**CITY OF LOS ANGELES**  
**INTER-DEPARTMENTAL CORRESPONDENCE**

3216 W 8<sup>th</sup> St  
DOT Case No. CEN20-52481

Subject: **UPDATED TRANSPORTATION IMPACT VMT ANALYSIS FOR THE PROPOSED HOTEL AND COMMERCIAL PROJECT LOCATED AT 3216 WEST 8TH STREET**

REVISED PROJECT SITE PLAN	FIGURE 1
---------------------------	-------------

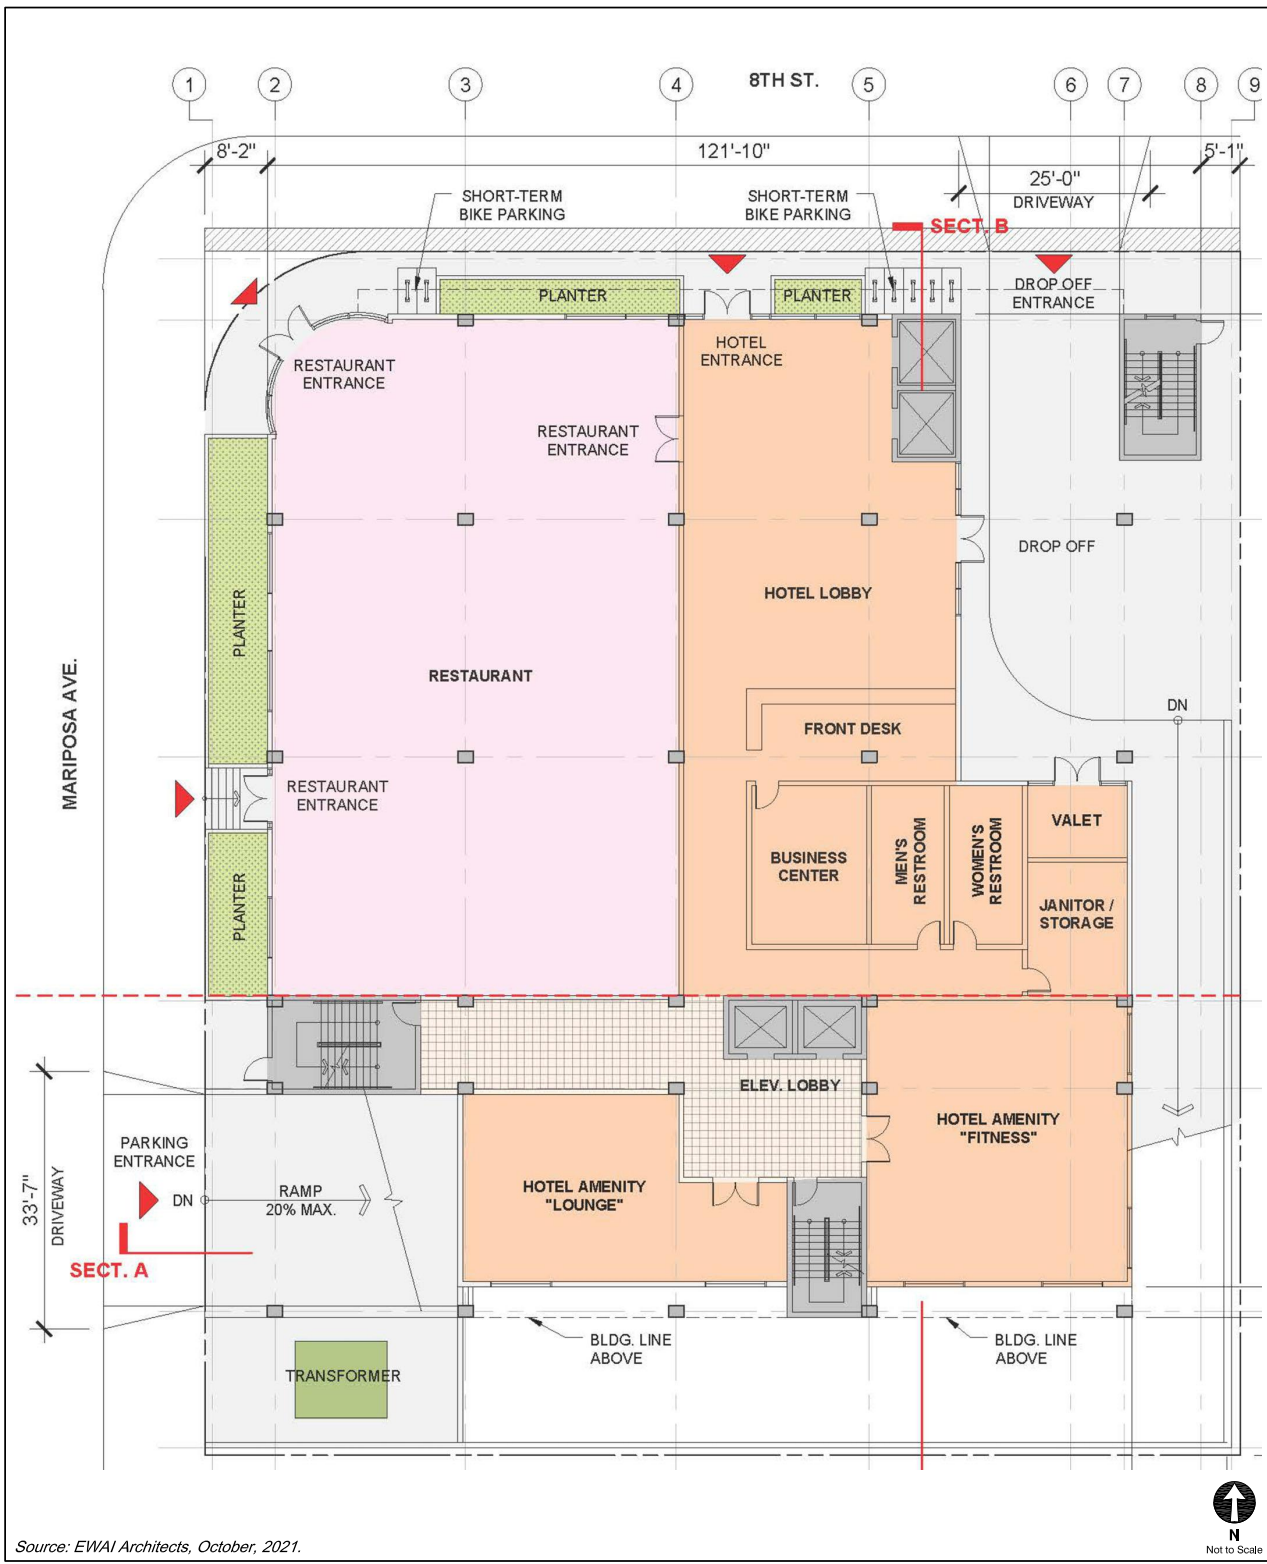
The proposed site plan illustrated in **Attachment C** is acceptable to DOT; however, review of the study does not constitute approval of the driveway locations, dimensions, access, and circulation scheme, and loading/unloading area for the project. Any changes to the project's site access, circulation scheme, or loading/unloading area after issuance of this report would require separate review and approval and should be coordinated with DOT's Citywide Planning Coordination Section at 201 N. Figueroa Street, 5th Floor, Room 550, at (213) 482-7024. The applicant should contact DOT for driveway width and internal circulation requirements prior to the commencement of building or parking layout design efforts so that such traffic flow considerations are designed and incorporated early into the building and parking layout plans. If any project driveway will be signalized, the applicant should contact DOT's Permit Plan Review Section [ladot.planprocessing@lacity.org](mailto:ladot.planprocessing@lacity.org) for review of the traffic signal plan. All new driveways should be Case 2 driveways and 30 feet for two-way operations and any security gates should be a minimum 30 feet from the property line. Should the project include a supermarket, DOT recommends that a dock manager and/or flag person be employed to assist delivery truck access to the loading area. DOT may recommend additional requirements once a complete review of the loading operations is conducted.
